To All Lamborghini Dealers and Licensed Service Point
From Customer Service Department
Subject Correct positioning of wirings in contact with engine bay
heat protection grid
Group 147.09.00
Attachments -
Date 16.01.2006
Pages 2

Correct positioning of the wiring in contact with engine bay heat protection grid.

Murciélago coupè (L147) models until VIN 1781

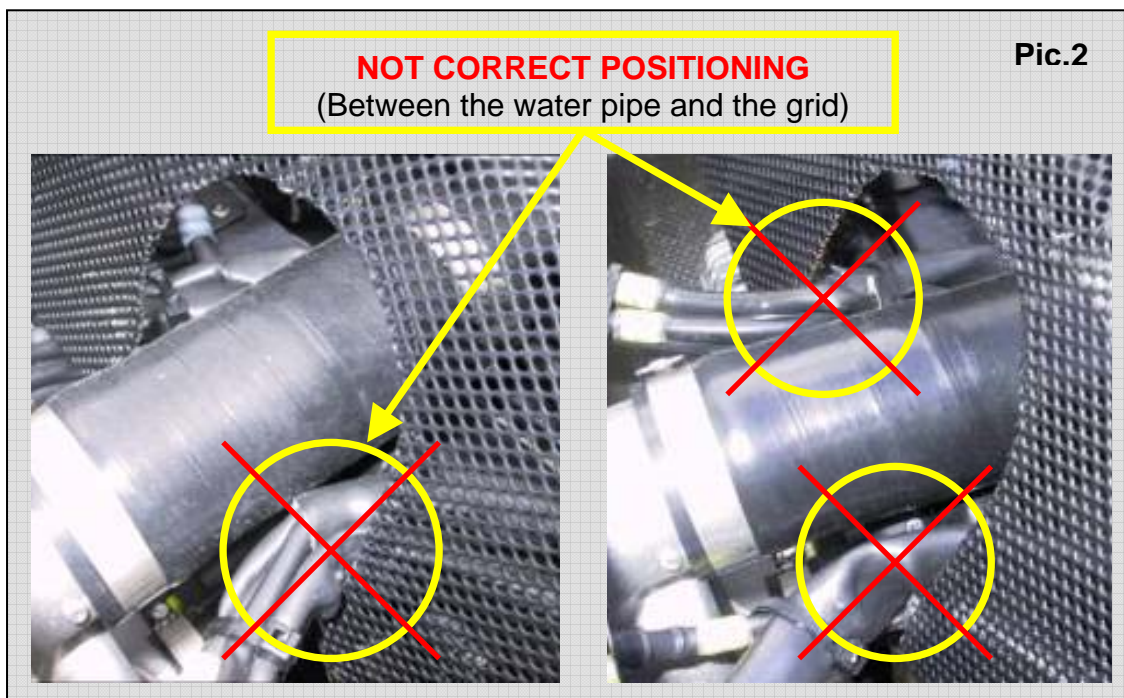
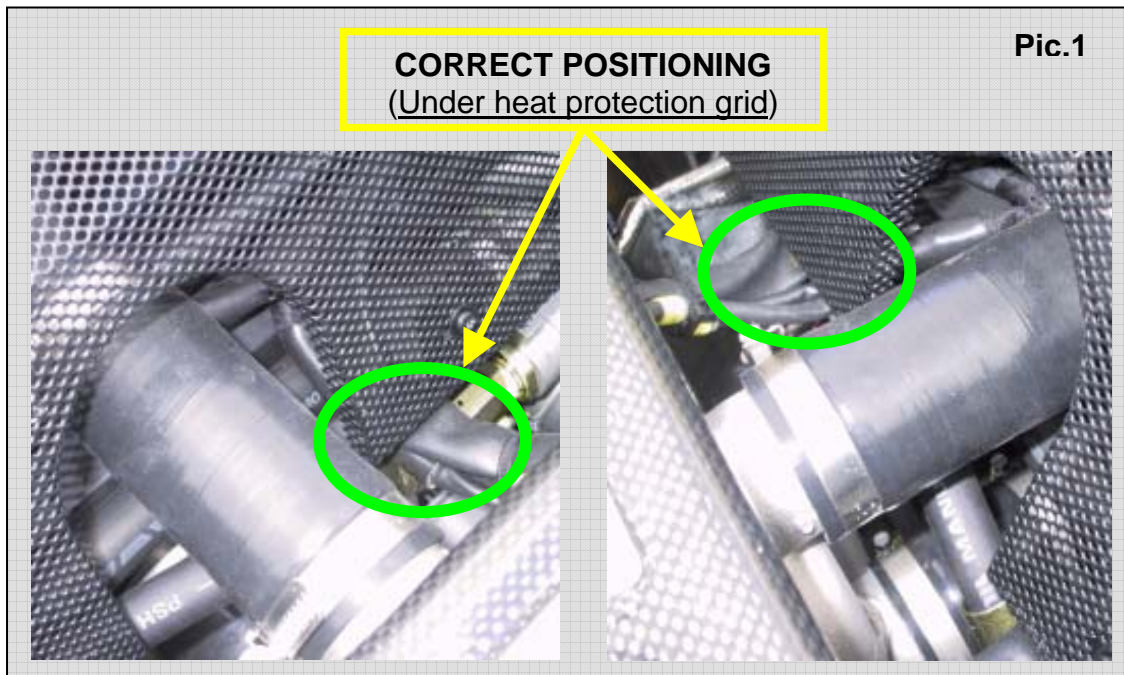
- 1.1 Adopt all precautions to prevent damage to the car and to work safe.
- 1.2 Check the position of the wiring in the contact point with the heat protection grid in the engine bay.

The pictures below show the possible position you may find.

- 1.3 If the wiring is not correctly positioned (Pic.2), re-position the wiring under the heat protection grid similar to shown in Pic.1.
